SECTION 00 91 15: SUPPLEMENTAL SHEETS

**Goldsboro High School – HVAC Renovations & Window Replacement
Goldsboro, North Carolina**

**End of Addendum #2
Issued June 9, 2023**

1 1st FLOOR PLAN - AREA C
M202 SCALE: 1/8" = 1'-0"

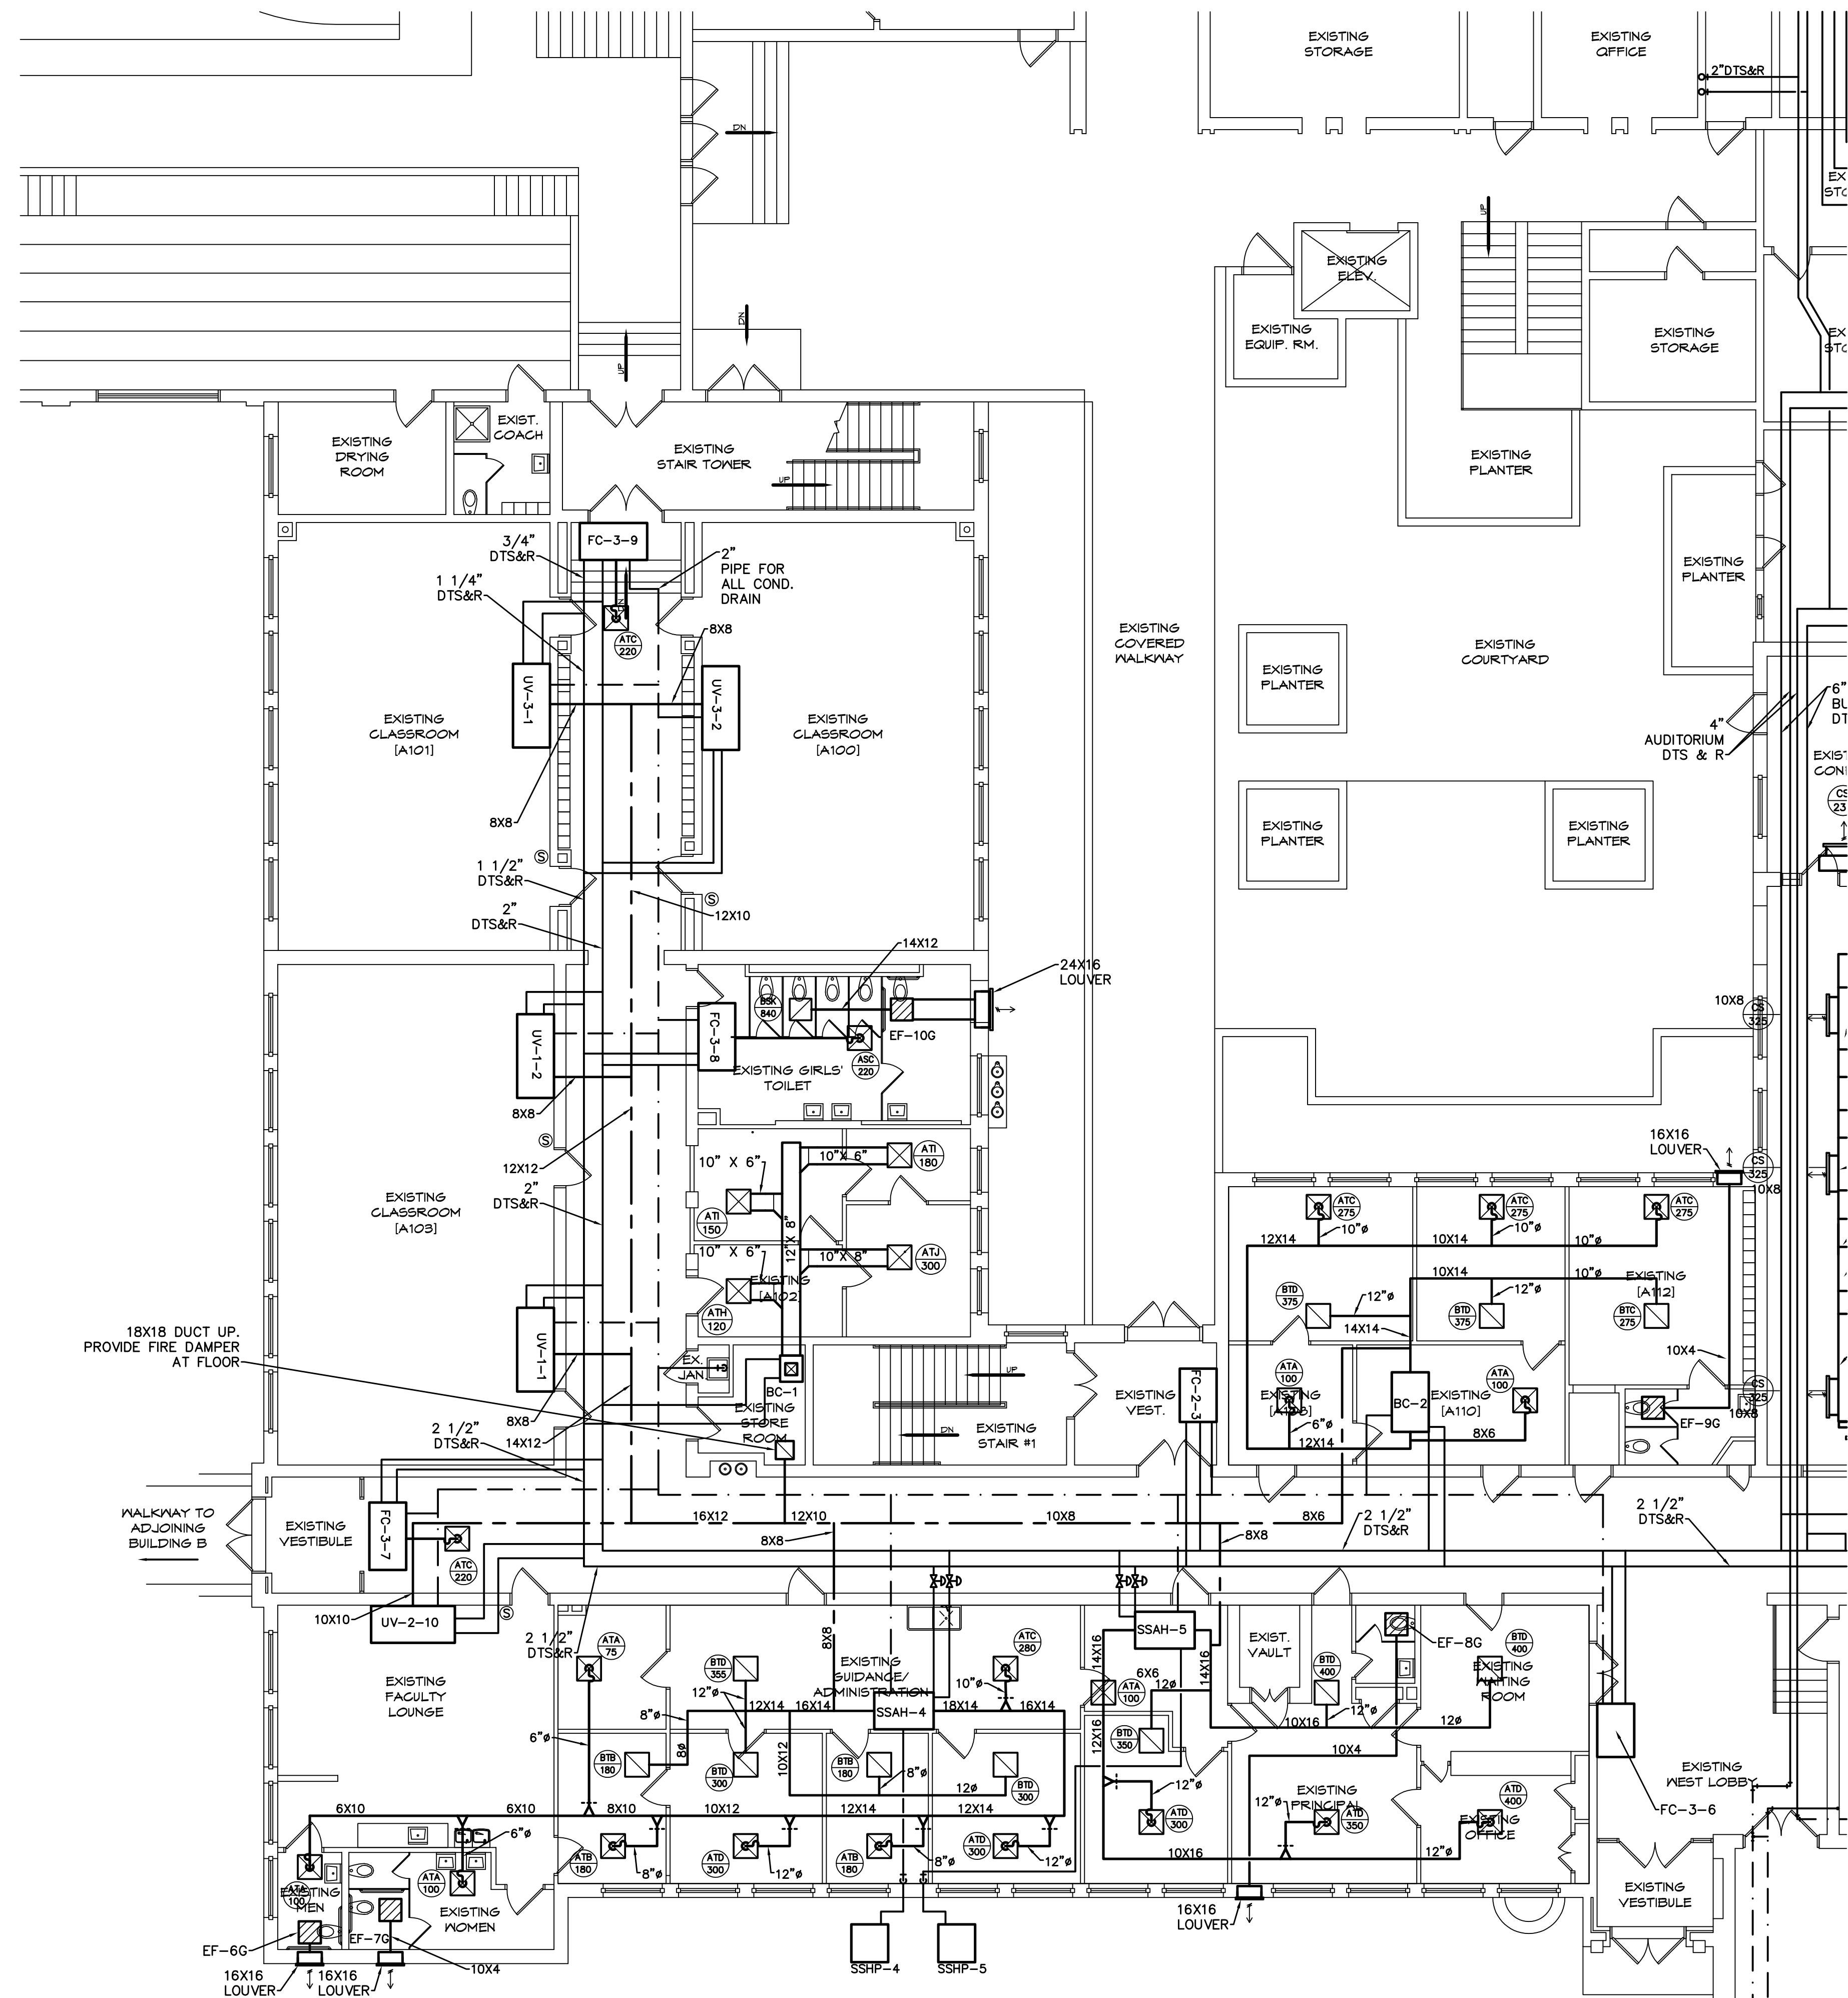
D. SHEET M202 FIRST FLOOR PLAN – AREA C – Delete this Sheet in its entirety and replace with SHEET M202 FIRST FLOOR PLAN – AREA C – Addendum #2 dated June 9, 2023
